Service Bulletin

PRELIMINARY INFORMATION

Subject: Retrofit Procedure for New Corded Folding Top Cover Installation to Original Design Frame

Models: 2011-2012 Chevrolet Camaro Convertible

Current Design #2 Bow Bracket

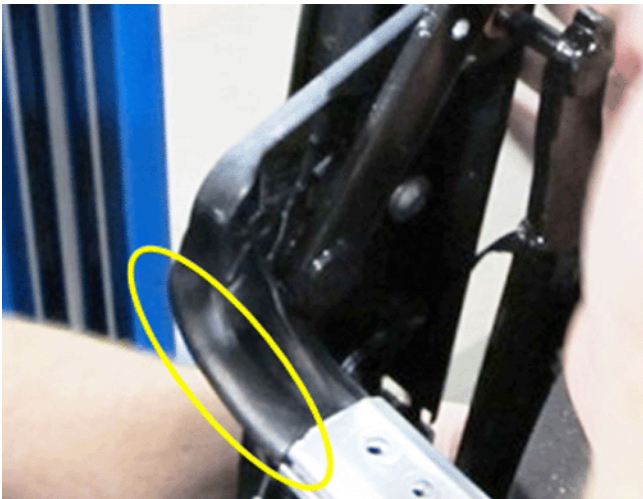
Important: The #2 bow end brackets are made of plastic and will likely break/snap during removal. Two new brackets are included with the top cover replacement kit. Regardless of breakage, all early design #2 bow brackets should be replaced.

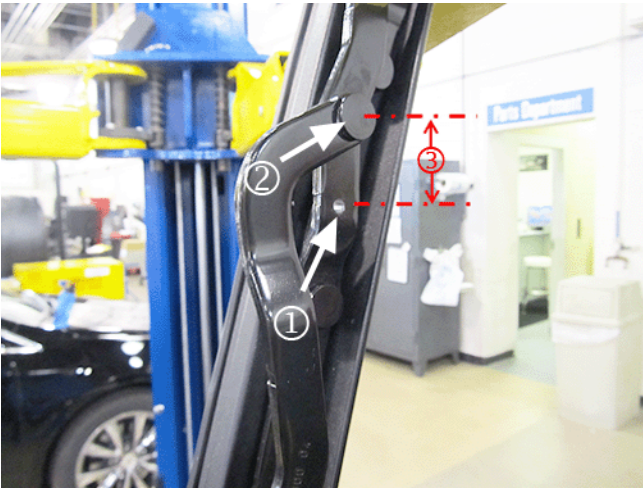
Important: The two holes added to the #2 bow should be centered on the bow and ARE NOT through holes. DO NOT drill through to the topside of the #2 bow.

11. While the #2 bow is removed, drill two 5 mm (0.197 in) holes (1) in the underside of the #2 bow. Position the holes 102 mm (4.0 in) from each end of the bow.

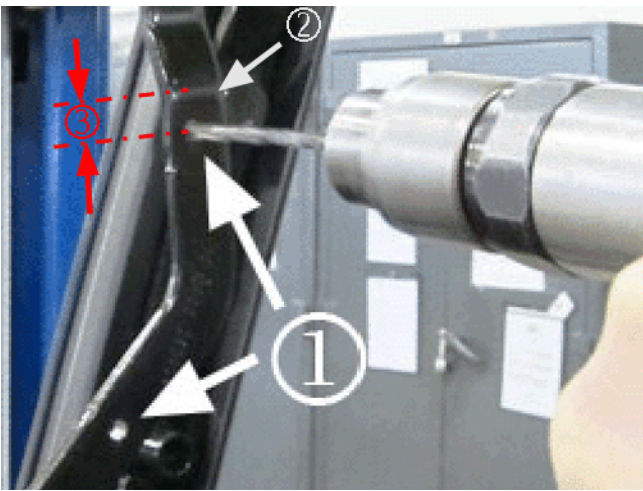
12. Centered on the left rear #1 bow link, drill a 5 mm (0.197 in) hole (1) into the link, positioned 35 mm (1.375 in) (3) from the center of the link pivot (2). Repeat the same operation on the opposite side of the top.

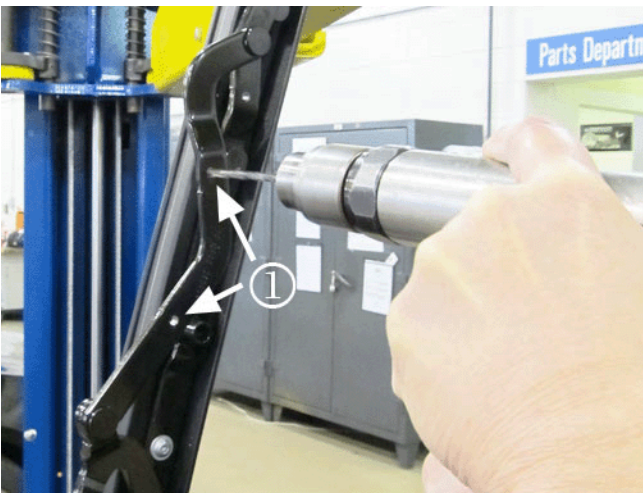
Note: Older convertible tops may be missing the upper 3.2 mm diameter hole shown in the control link above. If the hole is missing, add by drilling a new 5 mm (0.197 in) hole positioned 10 mm (.40 in) (3) from the bend radius (2). Repeat the same operation on the opposite side of the top.

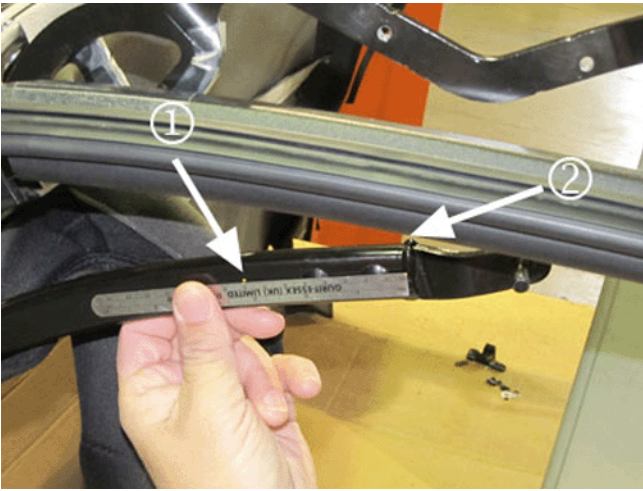
13. Re-drill the two existing 3.2 mm (0.125 in) holes (1) in the left control link to open the diameter up to 5 mm (0.197 in). Repeat the same operation on the opposite side.

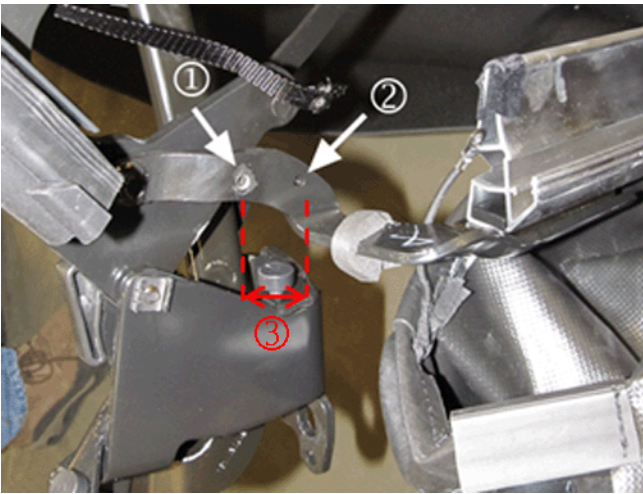
Important: The holes added to the each balance link are on the outboard side of the link and ARE NOT through holes. DO NOT drill through to the inboard side of the balance link. The right side balance link is shown in the graphic above.

14. Centered on the outboard side of the right balance link (1), drill a new 3.2 mm (0.125 in) hole, positioned 80 mm (3.15 in) from the center weld bead (2). Repeat the same operation on the opposite side.

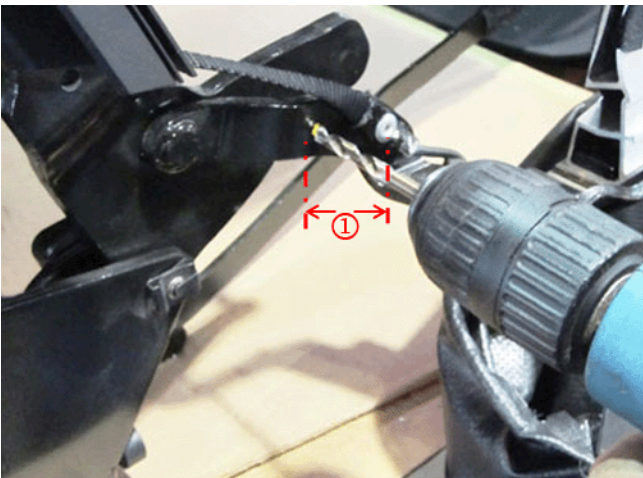
Important: The graphic above shows the left #5 bow bracket with the strap and cords removed, and also the orientation of the new hole (1) and existing hole (2) for illustration purposes only. The new hole may or may not be present and needs to be checked once the old top cover is removed. If the new hole is missing, add the 5 mm (0.197 in) hole to both the left and right #5 bow brackets.

15. Drill a 5 mm (0.197 in) hole into the left and right #5 bow brackets, positioned 30 mm (1.12 in) (1) from the hole where the rear headliner strap and water management bag cord are attached. Also drill out the rivet retaining the strap/cord for repositioning those to the new hole.

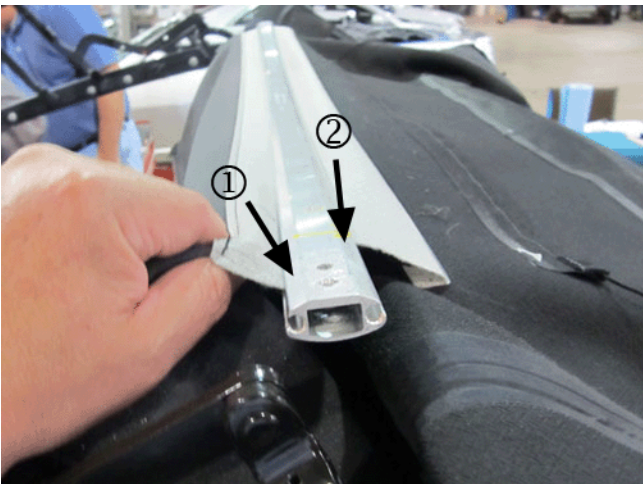
Important: The graphic above shows the headliner strap, which is attached to the 5 bow bracket AFTER the rivet was removed. If the top being retrofitted does not have a new 5 bow bracket with the new hole, then using a hot mandrel, or equivalent tool, burn a new hole (1) into the headliner strap. As shown above, locate the new hole 30 mm (1.20 in) (2) from the current location, then cut the reworked headliner strap at call out #3.

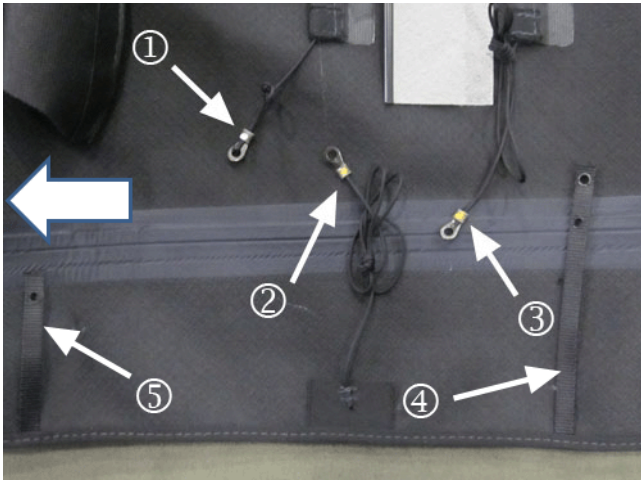
Note: The design of the top cover plastic retainer has changed slightly on the new corded top covers. The plastic retainer on the previous top covers had a slit near the end that allowed the side tension cable to pass through it as shown above.

Instead of a slit in the plastic, the retainer now has a large square hole at the very end, which is large enough to allow the cable anchor to pass through it. The retainer and square hole can be seen in the graphic below.
